Panel Report

Knox Planning Scheme Amendment C141

Upper Gully Strategic Plan

21 December 2016

Figure 2 Post-exhibition changes to DDO12

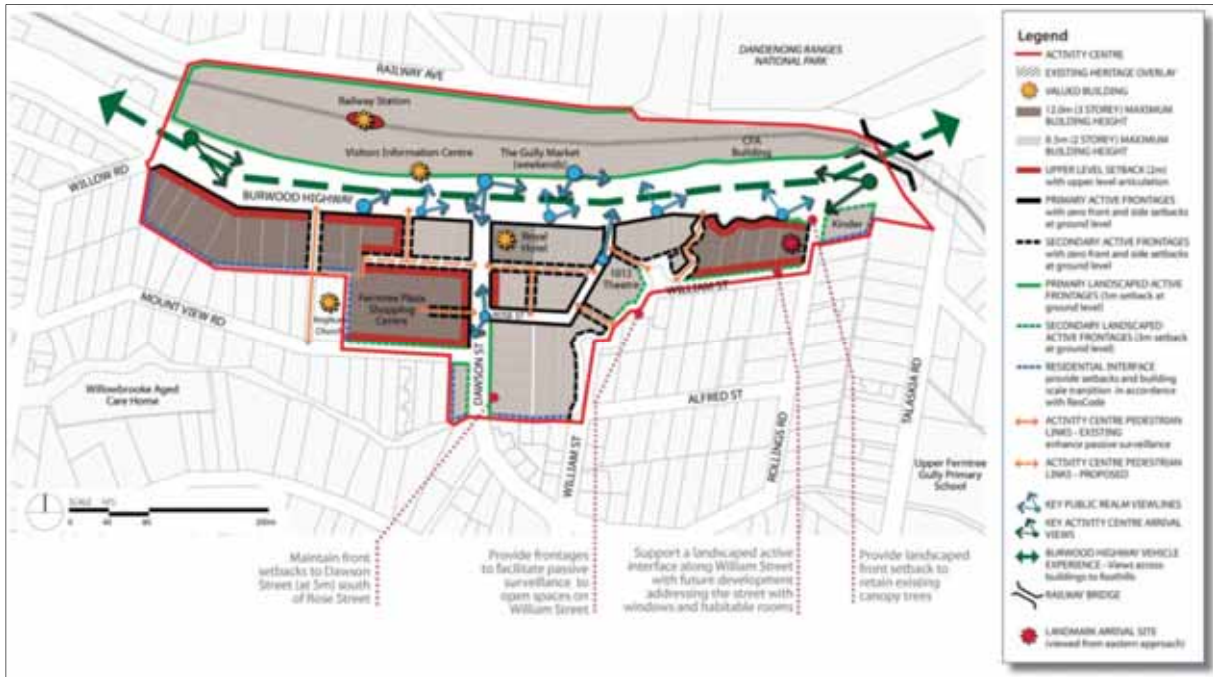
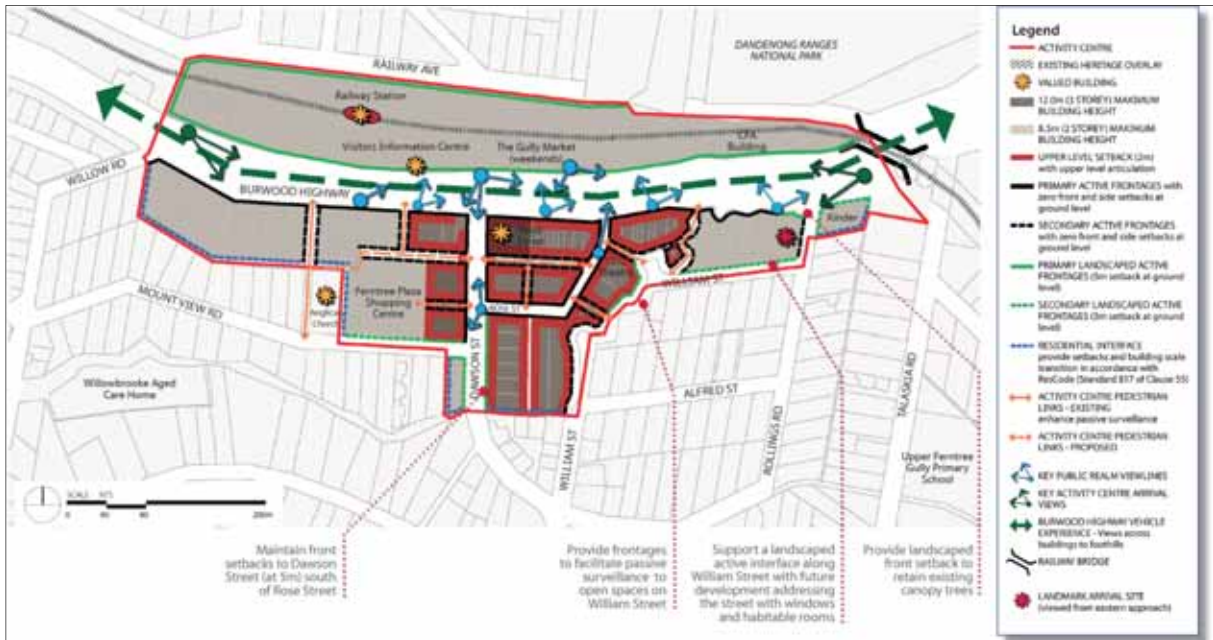
Following its meeting on 28 June 2016, Council decided to change the exhibited heights, as shown in Figure 2.

Many submitters criticised the Amendment for not aligning with the Strategic Plan that was based on a comprehensive strategic process involving stakeholders including the community. They criticised Council for not consulting before deciding to exhibit the Amendment with increased building heights and for not consulting before reversing these heights and increasing heights elsewhere after the Amendment was exhibited. Submitters concluded that Council's decisions were 'arbitrary' and were insufficiently justified after these changes were not formally explained.

Many submitters questioned Council's rationale for applying a 12 metre building height, originally to the flank areas, and later to the commercial core. They submitted that this height was not justified when Council's analysis showed that 8.5 metres satisfies all design and strategic requirements for the Activity Centre. Several submitters agreed that if the 1812 Theatre requires additional height for a *'fly tower'* then it should be specific to that site rather than applying it elsewhere and potentially compromising ridgeline views and the *'feel'* of the Activity Centre. Ms Whatman submitted that the three-storey proposal was largely

Based on comprehensive technical information in the Background Report, the Strategic Plan applied a mandatory 8.5 metre (two storeys) maximum building height to the Activity Centre. While there is comprehensive information to support an 8.5 metre building height, a conclusive explanation about why two storeys is more appropriate than three would have been helpful. There is insufficient information to explain why Council decided to change the building heights beyond what was recommended in the Strategic Plan before the Amendment was exhibited and insufficient information to explain why it sought to reverse the building heights and increase them elsewhere after it was exhibited.

While it is understood that the post-exhibition changes were in response to concern about potential capacity and viability impacts, there was insufficient information to support these claims or to understand the visual impact resulting from these changes. The land use and

3. Amend Design and Development Overlay Schedule 12, as shown in Appendix C, to:
 - a) Change the mandatory maximum building height to 8.5 metres (two storeys) for the entire Upper Ferntree Gully Activity Centre, except for the 1812 Theatre site at 1-3 Rose Street.
 - b) Change the mandatory maximum building height to 12 metres (three storeys) for the 1812 Theatre site at 1-3 Rose Street.
 - c) Add a new design objective under Clause 1.0:

Figure 3 Upper Gully Strategic Plan – Preferred setbacks and design outcomes for built form

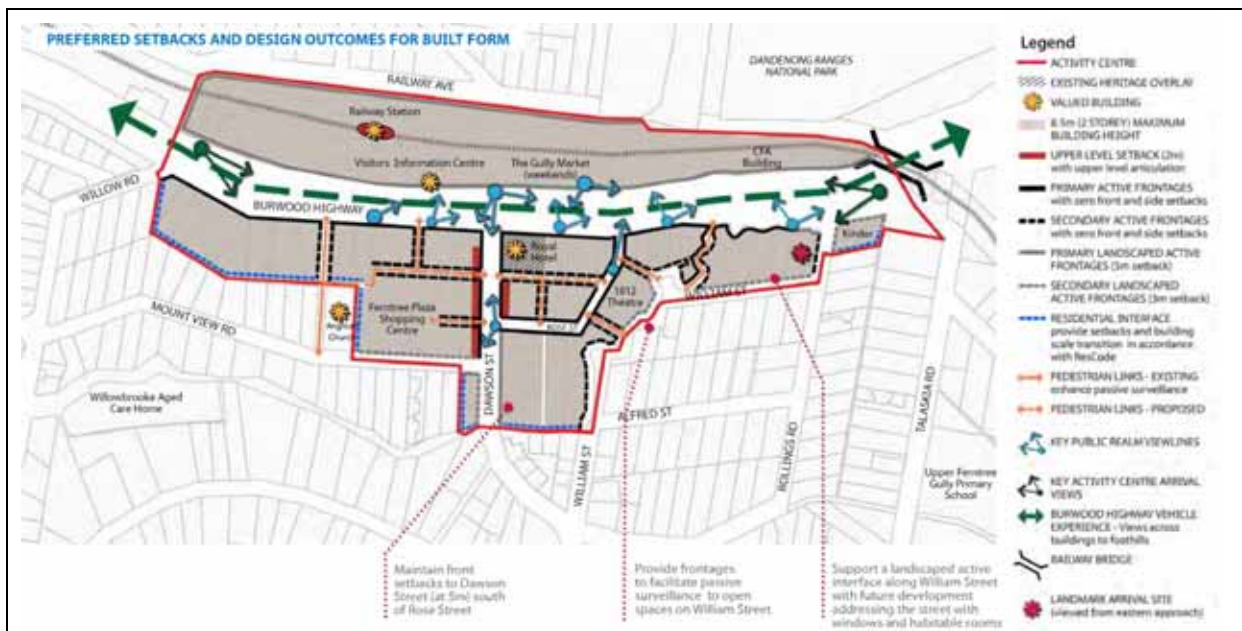
The exhibited Strategic Plan mirrors the Gully recommended pre-exhibition version except for the preferred setbacks and design outcomes for built form. The original Strategic Plan, October 2015 included preferred setbacks and design outcomes for built form, as shown in Figure 3. It proposed a mandatory maximum 8.5 metre building height to the entire Activity Centre.

At its meeting on 24 November 2015, Council resolved not to endorse the Strategic Plan in its recommended form for exhibition. It revised the heights shown in Figure 3 to those shown in Figure 1 and changed the date of the Strategic Plan to December 2015.

Figure 5 100 Year ARI flood depths

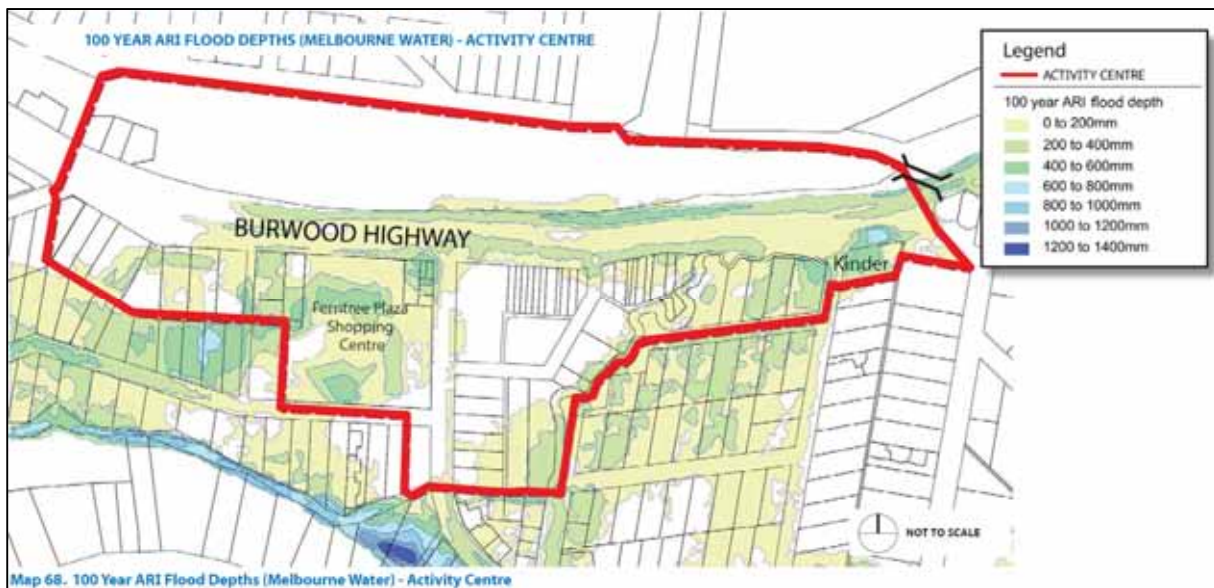
The Background Report identifies areas affected by 100 Year Average Recurrence Interval (ARI) Flood Depths sourced from Melbourne Water data.

Several submitters were concerned about localised flooding and included photographs of submerged local streets, and presented their accounts of flooding. They questioned whether further development was appropriate under these circumstances. Council noted that the Amendment proposes to change Clause 21.08 to add a new action:

Road and footpath levels are already set, and it appears problematic to provide a new development's driveway access with appropriate freeboard to ensure its basement does not flood. Potentially, the driveway apex may be up to 700 millimetres above the existing roadway level.

- The Amendment is unlikely to materially affect future flood conditions.
- Each site subject to flooding will be considered on its own merit.
- A new action in Clause 21.08 to develop comprehensive flood modelling would better inform future planning provisions, including overlays, and subsequently inform future planning permit applications.
